AMENDMENTS TO THE DRAWINGS:

FIG. 5

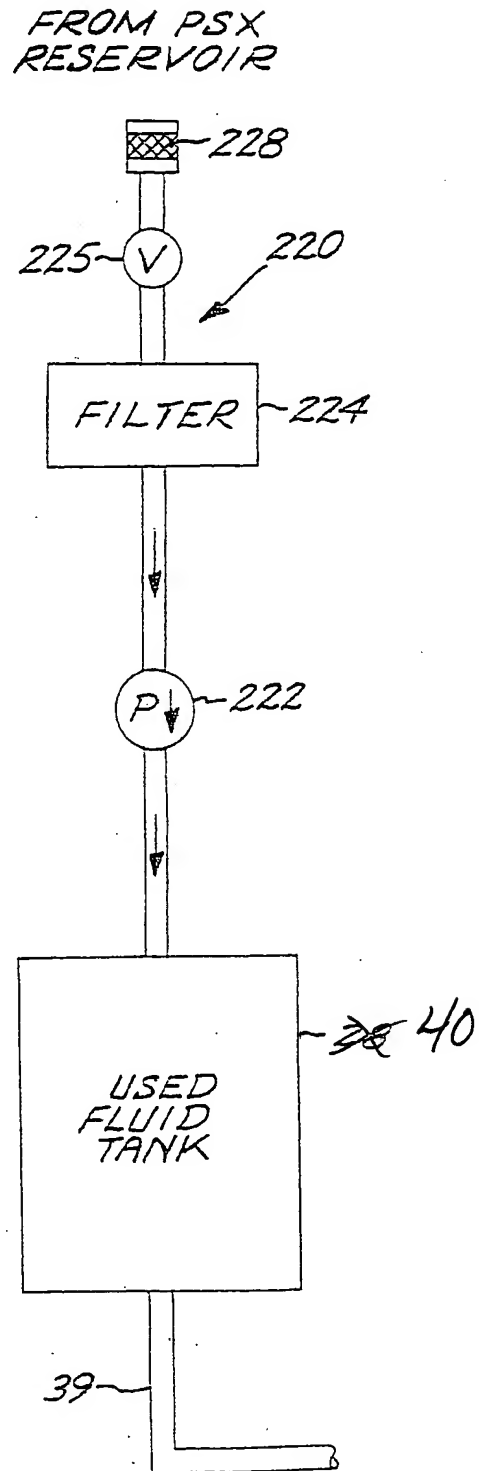
Applicant has amended FIG. 5 to replace the reference numeral "28" with "40" for the common used fluid tank. The Applicant has also corrected the lowermost occurrence of the reference numeral "40" to "42" indicative of the new fluid tank in FIG. 7. A set of drawing sheets with marked up FIGS. 5 and 7 is submitted herewith. Applicant also submits herewith a set of replacement sheets including these changes.
